Access Compliance Report

Public Rights-of-Way

(Curb Ramps)

Intersection ID: 13679	Main Street: EUCLID_AV	Cross Street: LEXINGTON_AV	Location: W
ADA ID: 653B1F5534AF	Ramp Type: Perpendicular	Initial Pass/Fail: Fail	Overall Compliance: No
Severity Score: 1.25			
Codes/Mitigation Info/Possible Solution		Field Measurements/Component Compliance

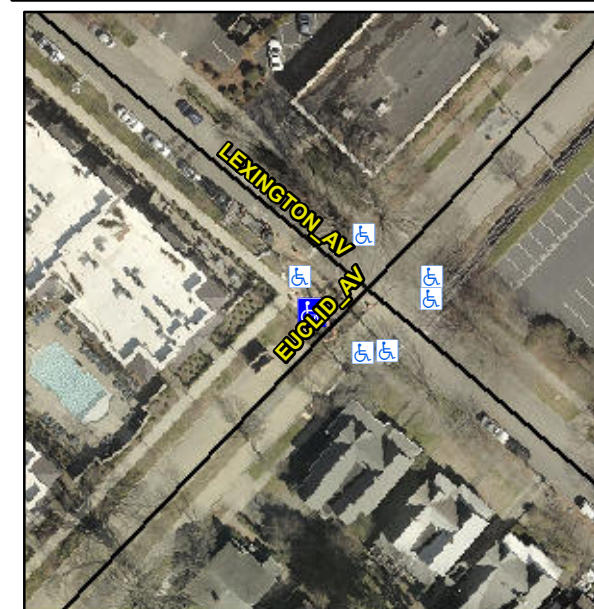
Compliance	Description	Data	Compliance	Description	Data
N/A	Ramp Length (in)	96.0	Yes	Ramp Slope (%)	6.8
Yes	Ramp Width (in)	68.0	No	Ramp XSlope (%)	3.3
N/A	Flare Type LT	N/A	N/A	Flare Type RT	N/A
N/A	Flare Slope LT (%)	N/A	N/A	Flare Slope RT (%)	N/A
N/A	Flare Traversable LT?	N/A	N/A	Flare Traversable RT?	N/A
N/A	Landing Length (in)	N/A	N/A	DWS Provided?	N/A
N/A	Landing Width (in)	N/A	N/A	DWS Contrast?	N/A
N/A	Landing Slope (%)	N/A	N/A	DWS Length (in)	N/A
N/A	Landing X Slope (%)	N/A	N/A	DWS Full Width?	N/A
N/A	Landing Curb? (Y/N)	N/A	N/A	DWS Offset (in)	N/A
N/A	Shared Landing?	N/A			
N/A	Gutter Ponding?	N/A	N/A	Gutter Slope (%)	N/A
N/A	Gutter Lip Ht (in)	N/A	N/A	Gutter X Slope (%)	N/A
N/A	Painted X Walk1?	No	N/A	Painted X Walk2?	N/A
	X Walk 1 Direction	To SE		X Walk 2 Direction	N/A
N/A	X Walk 1 Width (in)	N/A	N/A	X Walk 2 Width (in)	N/A
	X Walk 1 Slope (%)	0.1		X Walk 2 Slope (%)	N/A
	X Walk 1 X Slope (%)	1.5		X Walk 2 X Slope (%)	N/A

Remove & Replace Entire Ramp.
